UNITED STATES
NUCLEAR REGULATORY COMMISSION

SUBJECT: JUNE 2-4, 2003, MEETING SUMMARY: MEETING WITH DUKE
COGEMA STONE & WEBSTER TO DISCUSS CHEMICAL SAFETY
RELATED TO MIXED OXIDE FUEL FABRICATION FACILITY

**MEETING AGENDA
MOX FUEL FABRICATION FACILITY
June 2-4, 2003**

**MEETING SUMMARY
MOX FUEL FABRICATION FACILITY
June 2-4, 2003**

**Resulting Airborne Concentration as a Function of Wind Speed Over the Spill
(500 liters of 13.6 N Nitric Acid Spilled over 50 sq. m)**

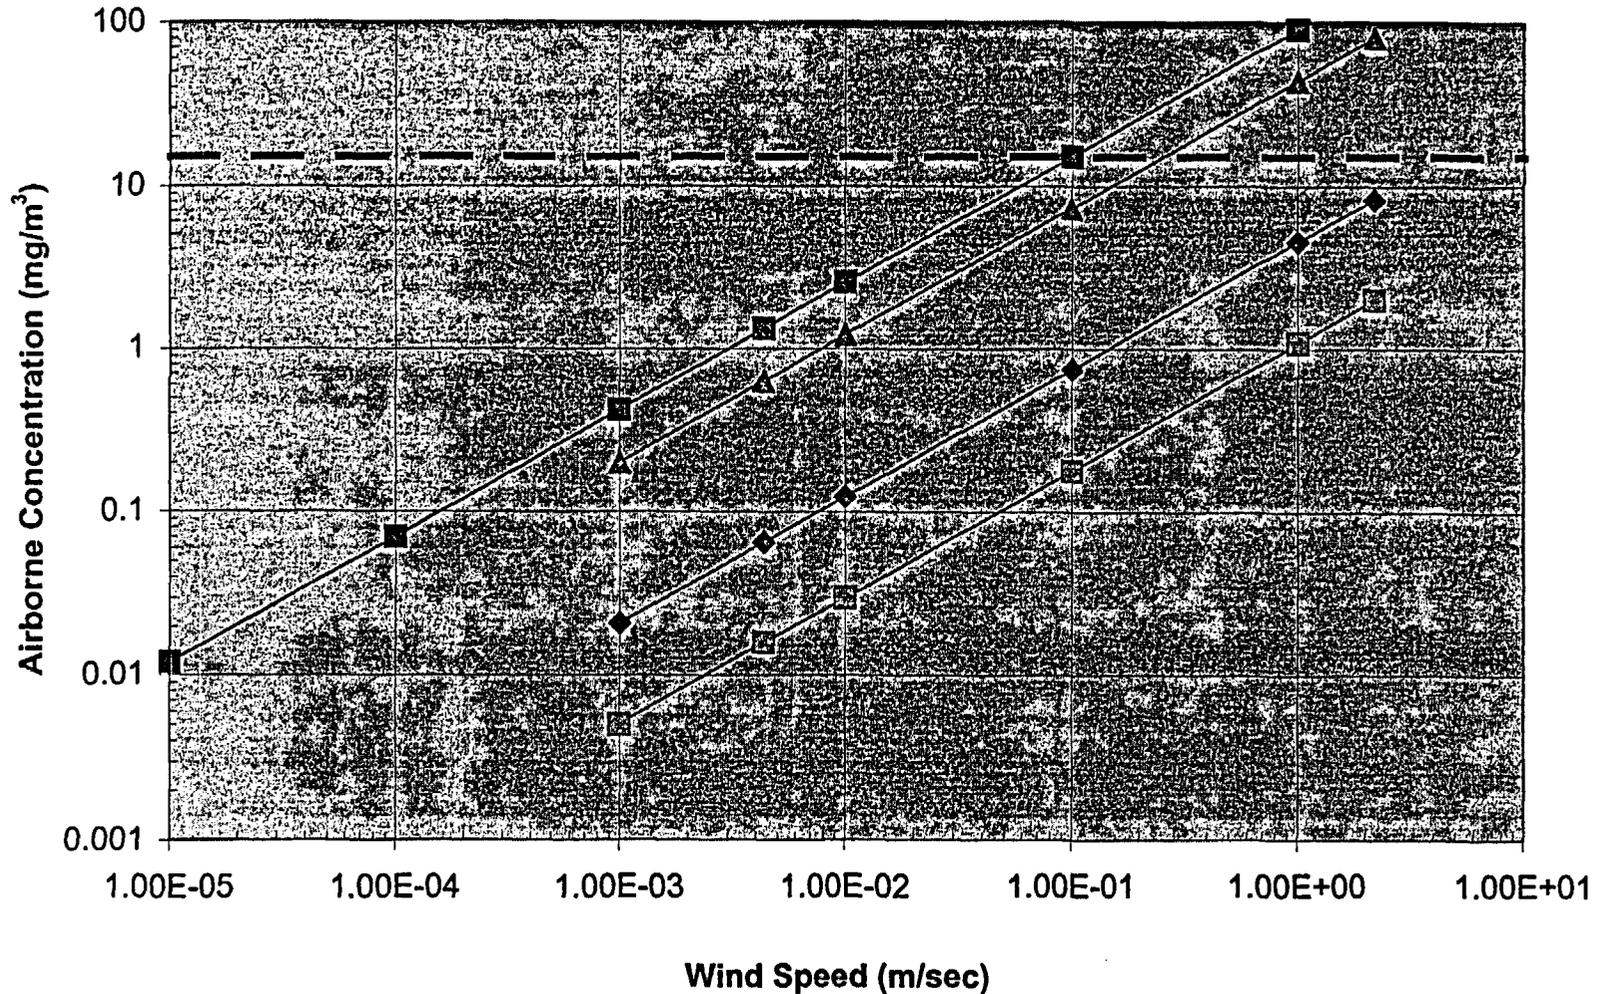
This item involved the effect of indoor airspeed on the calculational model used for determining whether a hot nitric acid spill in a cell could result in exceeding the performance criteria in 10 CFR Part 70. The applicant determined that for an uncontained spill and an average indoor airspeed of 0.01 m/sec, no consequence limits would be exceeded. The staff was concerned that the 0.01 m/sec airspeed was not realistic due to possible air duct locations near floor level that could significantly affect the evaporation rate of an uncontained spill. Specifically, the evaporation model is very sensitive to airspeed above the spill and an increase to 1 m/sec could exceed the low consequence limits. Additionally, the evaporation rates increase with temperature and could be substantial for temperatures above 110°C.

The staff conducted independent calculations using three different techniques (the guidance in NUREG/CR-6410, Nuclear Fuel Cycle Facility Accident Analysis Handbook, ALOHA and EPICode) and determined that the indoor air speed would conservatively have to be greater than a factor of five times the assumed average wind speed of 0.01 m/sec. to exceed the ERPG-2 value for a hot nitric acid spill (119°C) in the C-105 cell floor to exceed the low consequence limits for the site worker. The calculations assumed that the spill covered the entire 60m² floor area and did not take into account the conservative effects of the spill catch pan under the tank that is designed to contain the entire tank volume, or cooling from contact with the floor surface.

In addition to the above, DCS will do a cell by cell review during the ISA to confirm that low consequence limits will not be exceeded for any uncontained spill. Should the limit be exceeded, DCS indicated that the existing spill catch pan, already a principal structure systems and component (PSSC) for other scenarios, would be upgraded to a PSSC for this scenario. Since (1) there is a substantial indoor airspeed margin, (2) a cell by cell review will be conducted during the ISA, and (3) should the low consequence limits be exceeded for any cell assuming an uncontained spill (i.e., no catch pan), the applicant will upgrade the existing devices to PSSCs without impact on any construction activities, the staff considers this item closed.
